Staff Report

Agenda Date: June 26, 2023
Agenda Item: Variance Request 2320 Meridiana

Project Description: Variances to regulations of the Unified Development Code pertaining to Master UDC Section 3.5.3.12- Storefront Code; Transparency.

Variance Request:

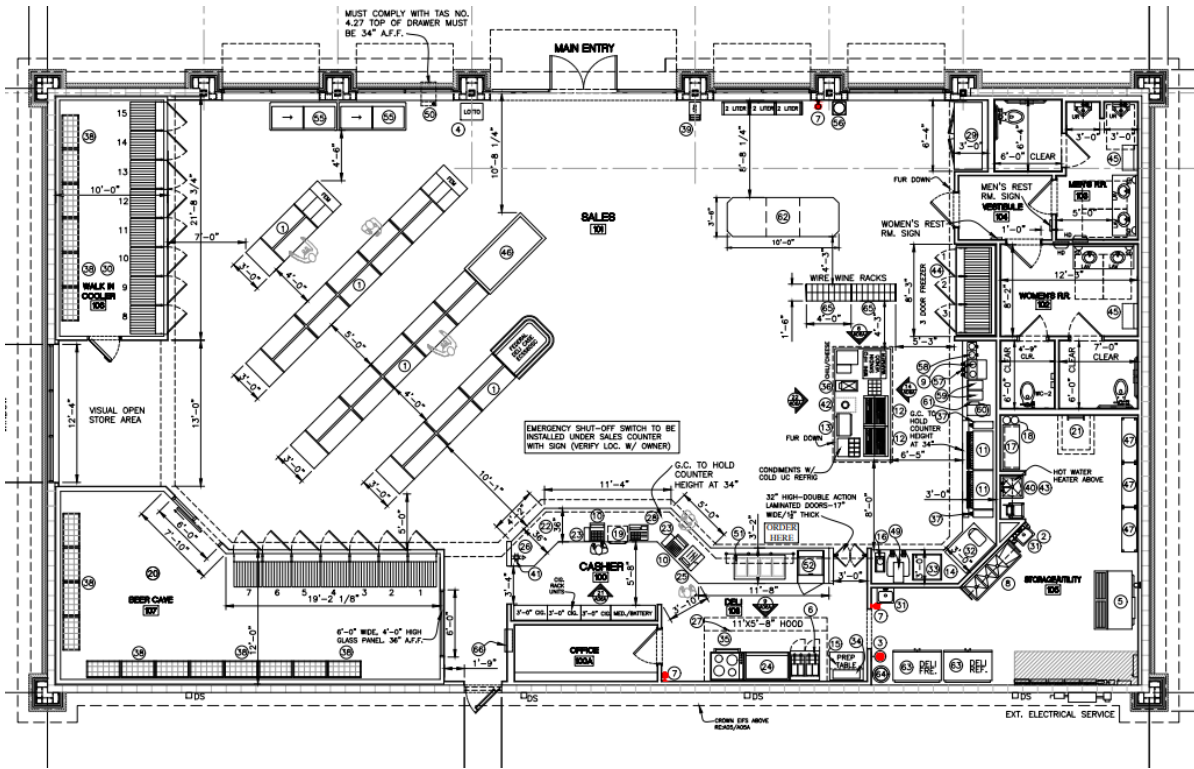
The architectural floor plan does not allow for glazing walls on the East or the Westside of the building, as they enclose the walk in cooler and public restrooms. Please refer to the floor plan attached for reference.

Additionally, kindly consider that the use of this facility requires a level of security and privacy for all interior sales inventory, such as but not limited to, ATM Cash Unit, Lotto Tickets, Carton Cigarettes, Alcoholic Beverages and Cashier Safe.

This project is located at the corner of Meridiana and Crystal View Drive, the project complies with the North elevation facing Meridiana Parkway but not the West elevation facing Crystal View Drive.

On Tuesday June 6, 2023, this variance was taken in front of the Planning and Zoning (P&Z) Commission. During the meeting it was shown to the commission that this project did not meet the Unified Development Code Section 3.5.3.12. Storefronts Sub-section (b) Transparency. Due to the timeframe and the delay of this project, the P&Z Commission allowed city staff to work with the property owner and designer to come up with a design that would come close to meeting the intent of the UDC. We met with the designer of the project via phone and requested a minimum of 25% transparency with view to the point of sale. The designer made the adjustments as requested. City staff recommends that we allow this project to move forward with the transparency as designed on the Westside of the building facing Cystal View.
